Contract #: 04-0120F4Cty: SF/ALA Rte: 80 PM: 13.2/13.9File #: 69.25B**QUALITY ASSURANCE -- NON-CONFORMANCE REPORT****Location:** Changxing Island, Shanghai, China**Report No:** NCR-000992**Prime Contractor:** American Bridge/Fluor Enterprises, a JV**Date:** 18-Mar-2011**Submitting Contractor:** Zhenhua Port Machinery Company, Ltd (ZPMC), Changxing Island**NCR #:** ZPMC-0950**Type of problem:**

Reference Description: Missed UT Indication Discovered by QA on Segment 13CE RS Stiffener Weld at SP3075A

Subject: NCR No. ZPMC-0950

NCR PROPOSED RESOLUTION

Description of Non-Conformance:

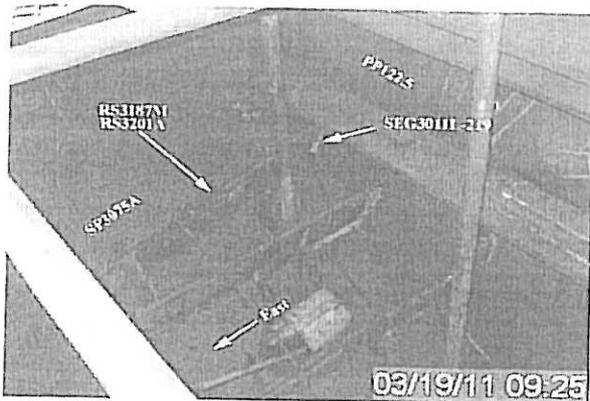
During Quality Assurance (QA) Ultrasonic Testing of OBG Segment 13CE. This Quality Assurance inspector discovered the following issue:

- A total of one (1) Class 'A' longitudinal indication measuring approximately 10 mm in length in the side panel rib stiffener (RS3187M) attachment to the floor beam web, east of panel point 122.5.
- The indication dB rating is -1db.
- Material thickness is 22 mm and depth of the indication is approximately 16.74 mm.
- The 'Y' location of the indication is 40 mm.
- The weld is identified as SEG3011L-219.
- The indication is clearly marked near the weld.
- Segment 13CE is located in Bay 14.

The notice of witness inspection (NWIT) no. is 08574. The indication is located within the area which was previously tested and accepted by ZPMC Quality Control (QC) personnel. As per contract documents, ZPMC's QC personnel are required to perform hundred (100%) percent UT inspection of this weld.

Reference Resolution: ZPMC has repaired the indications noted in the NCR and is providing WR & NDT documentation after the repair to show the indication has been removed.

This proposed resolution is acceptable. The documentation received is sufficient and the Department concurs that Non-Conformance ZPMC-0950 is closed.

焊缝返修位置示意图:
 Draft of welding discontinuity:

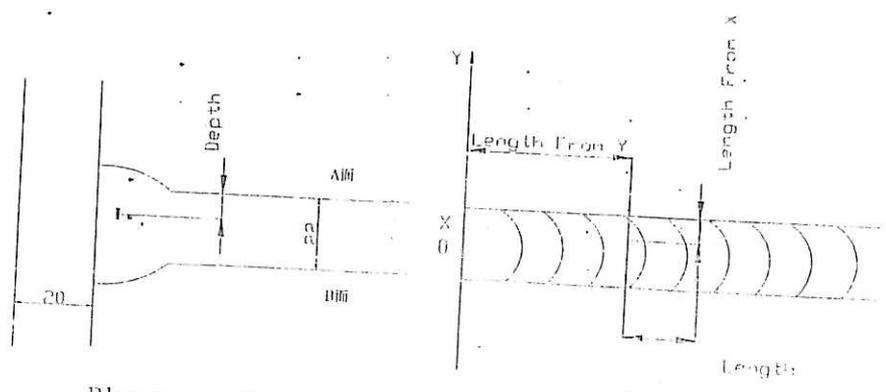
焊缝缺陷描述: (普通UT探伤发现的缺陷长度小于最大允许长度)
 (Description of welding discontinuity): Rejected indication found by ultrasonic inspection is less than the maximum allowance aggregate length.
 焊缝编号为: SEG3011L-219

1. 焊道未及时处理干净。
1. Did not clear the weld pass completely in time.

1. 从缺陷距离端面较近一侧 ($D \leq 0.65T$, D 为缺陷深度, T 为板厚) 采用碳刨或打磨的方法去除焊缝缺陷;
 2. 参照返修焊接工艺规程 (WPS) 准备正确的接头型式, 预热和焊接;
 3. 将修补区域打磨到与母材或邻近焊缝平齐;
 4. 根据批准的车间图纸检查焊缝.
-
1. Gouge or grind from nearer side from metal edge ($D \leq 0.65T$, "D" is depth of defects, "T" is thickness of metal) to remove all defects;
 2. Follow repair WPS for joint preparation, preheat, and weld deposit;
 3. Grind the repaired area flush with base metal or the adjacent weld;
 4. Check the welds according to the working drawings.

1. Improve monitoring of welding and interpass cleaning.
